GOVERNMENT OF MADRAS.

PUBLIC WORKS DEPARTMENT.

Division Office at Chettipet

Instructions to Superintending Engineer,
I Circle, for preparing estimate for a new
building for the —.

Godavari De...
Western Det...
Plan of Dr... office

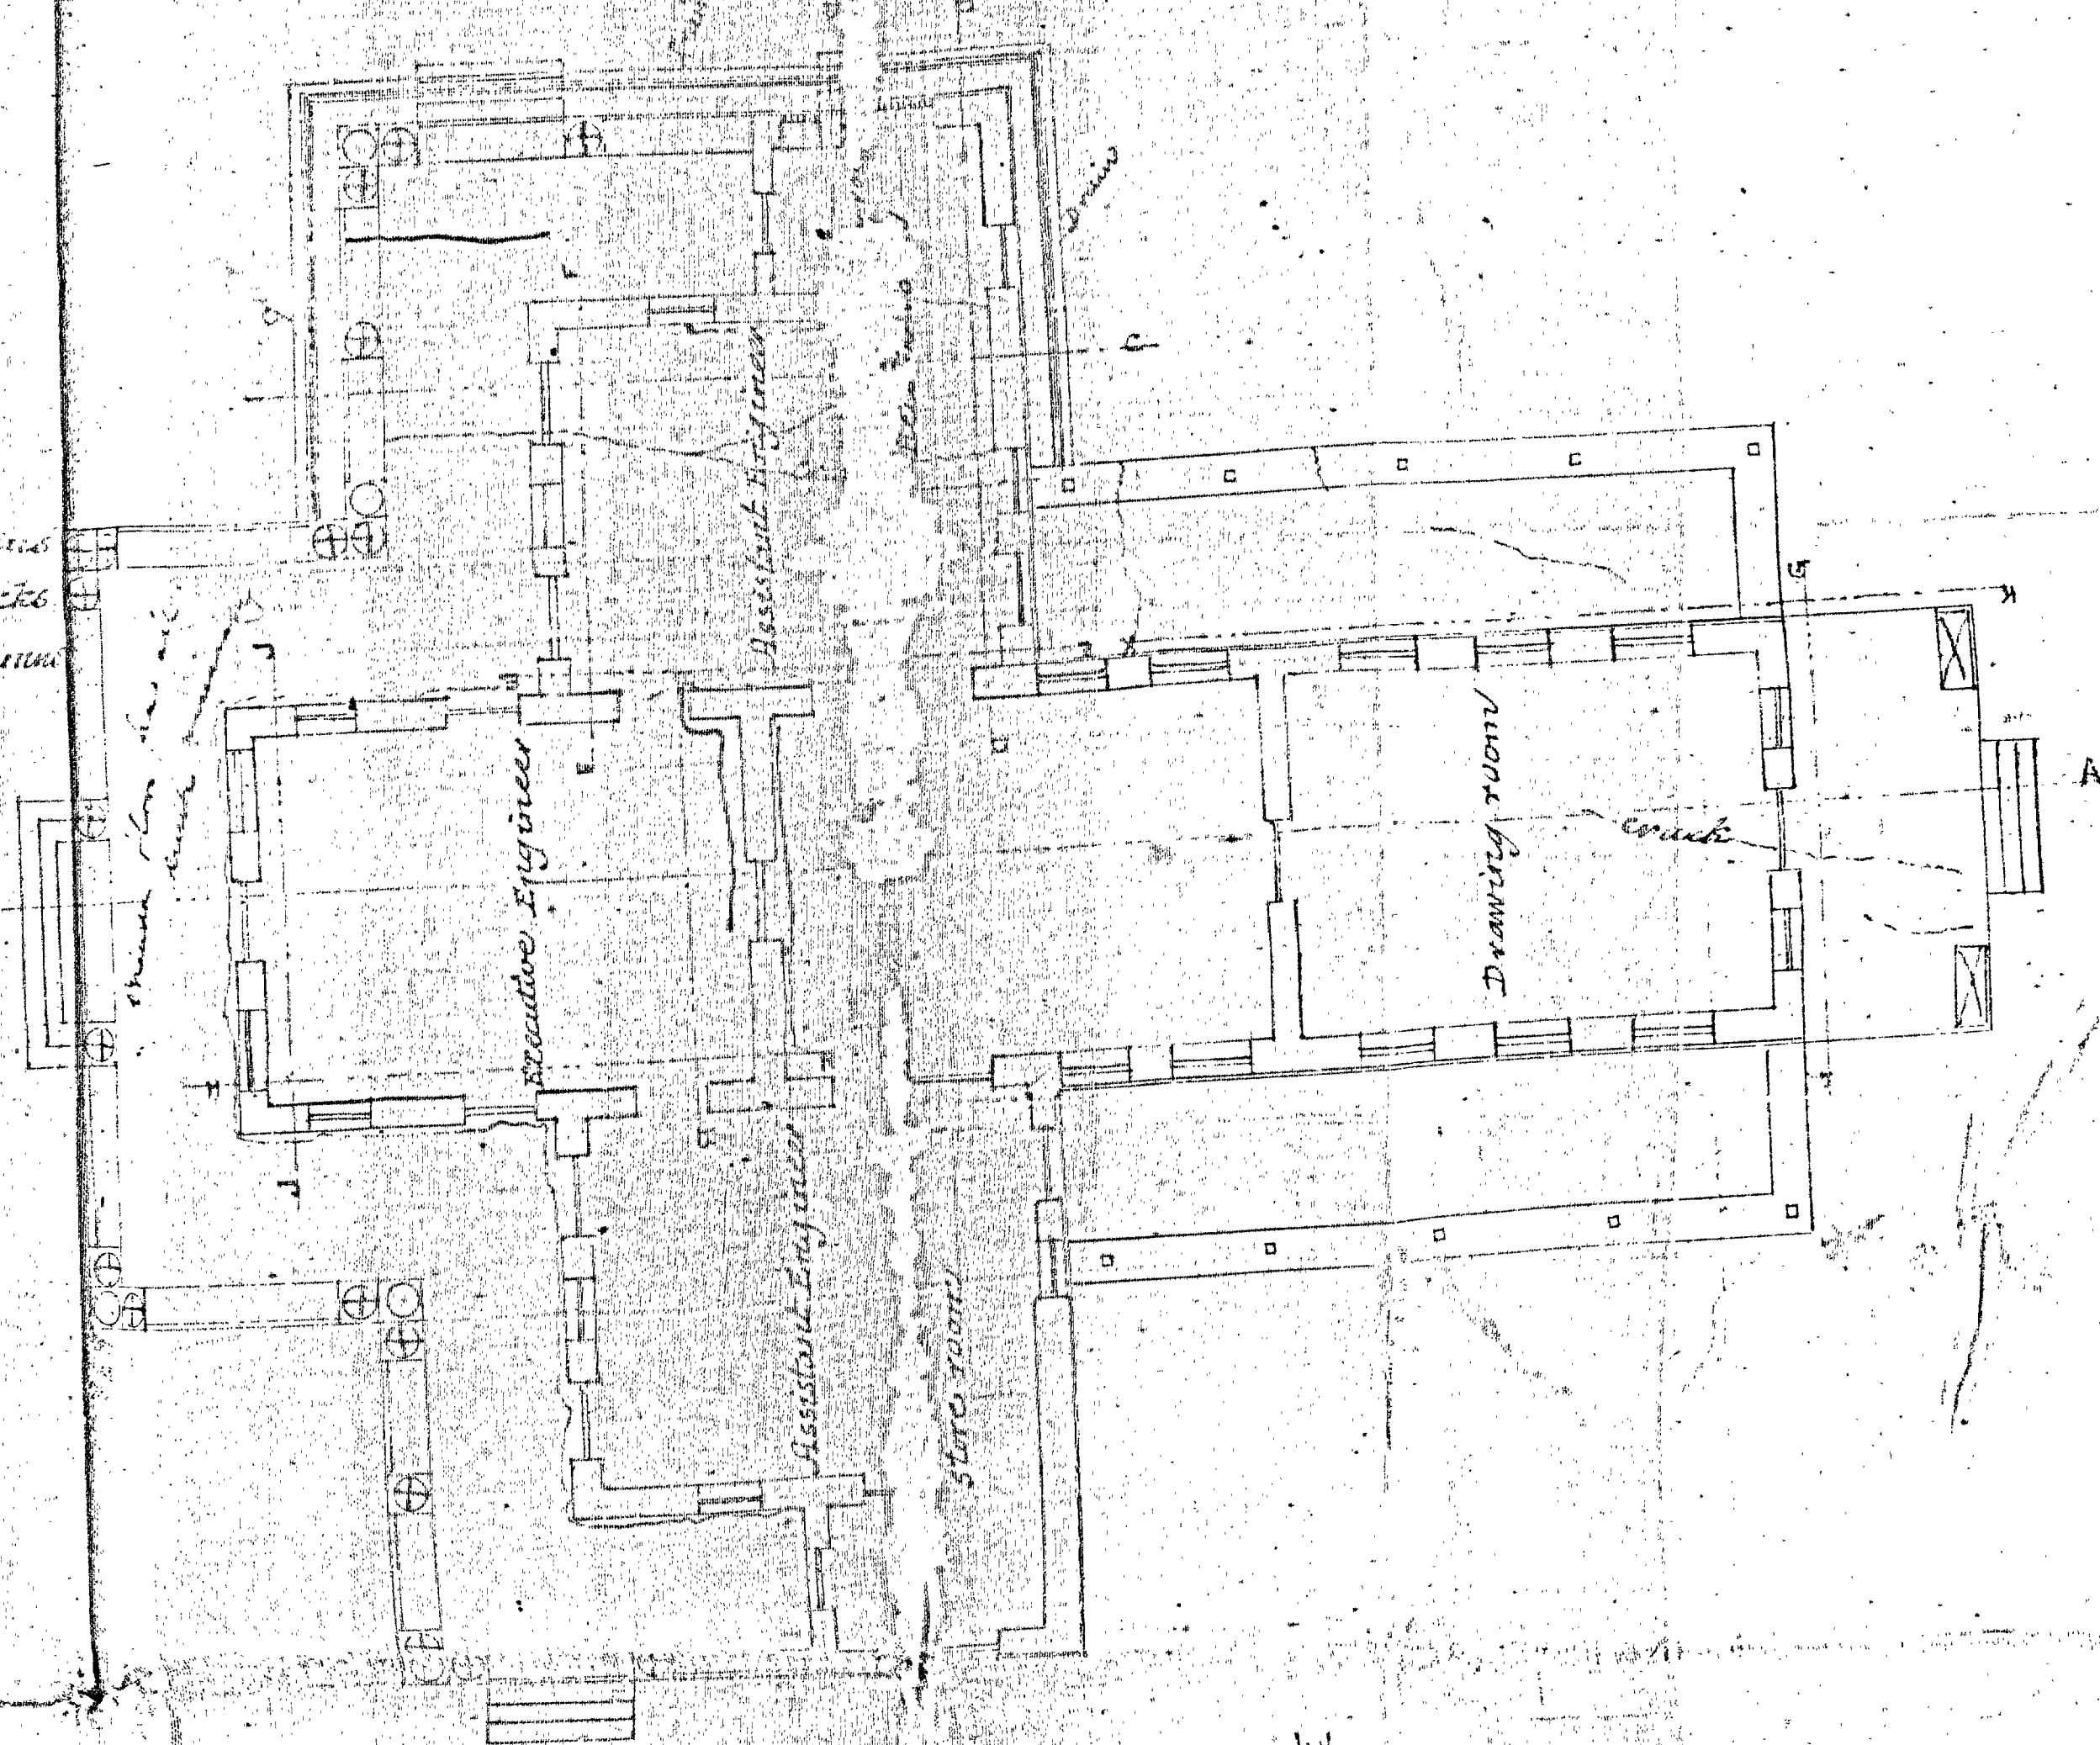
2. I enclose a tracing and copy of a letter from the Assistant Engineer in charge of the division giving details of the cracks. The office was constructed in the year 1877 at a cost of Rs. 11,882, and for many years showed no signs of cracking; in fact it was not till after the floods of 1886-87, when the compound was under water for several days, that any serious settlement took place, and it is only in the last few months that the cracks have been getting rapidly worse. The soil on which the building stands is extremely bad and I measured some cracks in the vicinity nearly 6' deep, and I think the failure is due to the ground cracking after being thoroughly saturated by the floods.

3. I thought that perhaps the drain (shown in tracing) at the back of the building and which is in rather a peculiar position might have had something to do with the failure, but I examined it and found it in good order.

I am surprised that the building which has stood well for upwards of 12 years should have suddenly come to such grief. There cannot be any doubt whatever that it is entirely due to movement of the ground, due probably to its having been flooded.

2. The Superintending Engineer should have described the foundations or shown them on the tracing; they are easily ascertainable from the existing plan of the work as built and other records.

4. The *old* cracks in the verandah pillars (on the *outside* of them) undoubtedly arose from the drag inwards of the top of the pillars when the verandah rafters sagged slightly as they had been notched to the bressummers too rigidly; those cracks had nothing to do with the present state of affairs. I see nothing for it but to pull down the building and erect another on the same general plan, so that roof timbers, doors, windows and other woodwork and fittings (the most expensive part of the building) may be used again, and of course the tiles and many of the bricks will be fit to use again.

5. In rebuilding I would keep further away from the weir channel and from the canal.

The Superintending Engineer, I Circle, will prepare an estimate for a new building with reference to the remarks of the Chief Engineer for Irrigation. The office can, in the meanwhile, be accommodated as suggested by Mr. Walch.

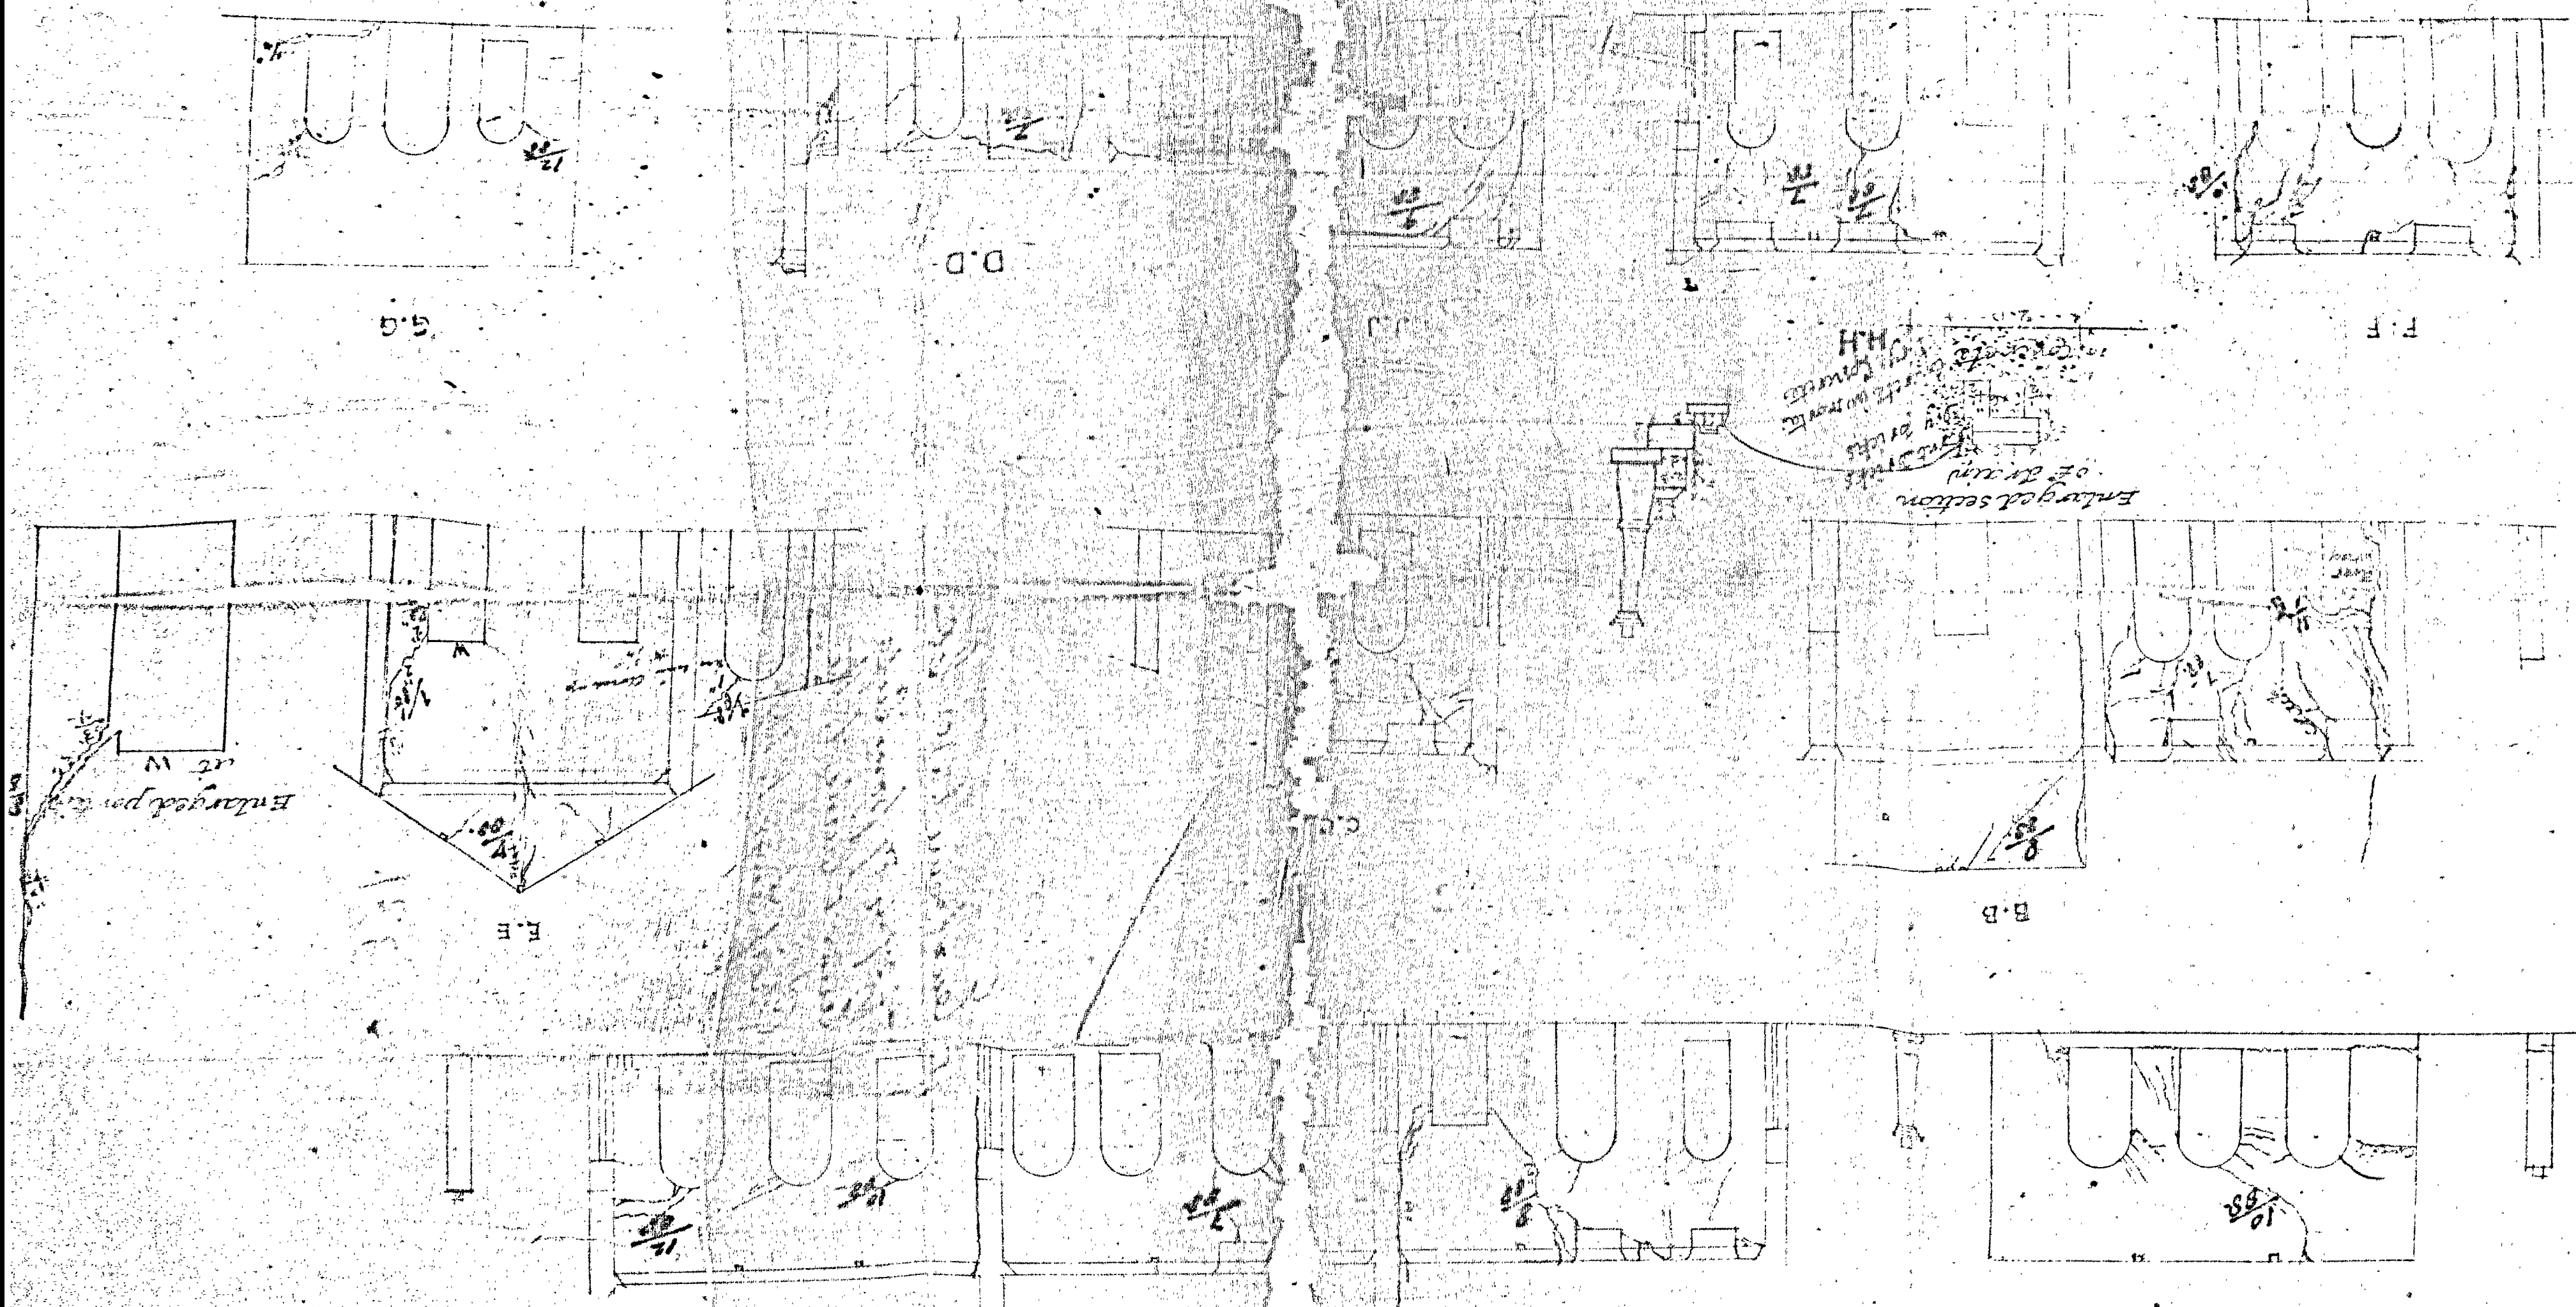
the plaster on the West wall is
being cracked out at about the
level of Verandah roof.
The West cracks at present are
(1) the one above mentioned
(2) the three cracks shown in section
III. The one on the left of the section
was at one time about 2 months ago
1" wide but has since closed up the
lower part of the wall has moved
up to the W. $3/4$ to S. The center crack
is the most dangerous. It is widest
under the ridge about $3/4$ " and the
upper part of the wall is falling
over towards the Assistant Engi-
neers Office, this crack has increased
rapidly & joined quite recently
to that from the left hand
angle of door marked W. The
crack which is shown in the enlarged
elevation has not increased much
recently but when it first began
widened rapidly. This crack shows
a movement of the lower portion
of

of the wall of $3/4$ " west & $3/4$ " South. The
cracks in the draftsmen's office are
all recent and are still increasing.
New cracks are also appearing in the
arches of windows in Draftsmen and
31 Executive Engineers Office rooms. This
extensive cracking of the office seems
mainly to have taken place since
1) the construction of the back drain
& 2) the 1886 floods. The drain how-
ever as you saw seems to be in good
condition. The crack in the angle
filler at the S.W. corner occurred I
believe before the drain was laid
and was I think attributed by G.
J. Walsh Esquire when Superintending
Engineer to the dragging of a Bream-
mer. I have ordered according
to your instructions that the Execu-
tive Engineers Office is not to be
used. I believe I informed you that
the building was of rough stone &
plastered this was incorrect as the
building is all of brick.
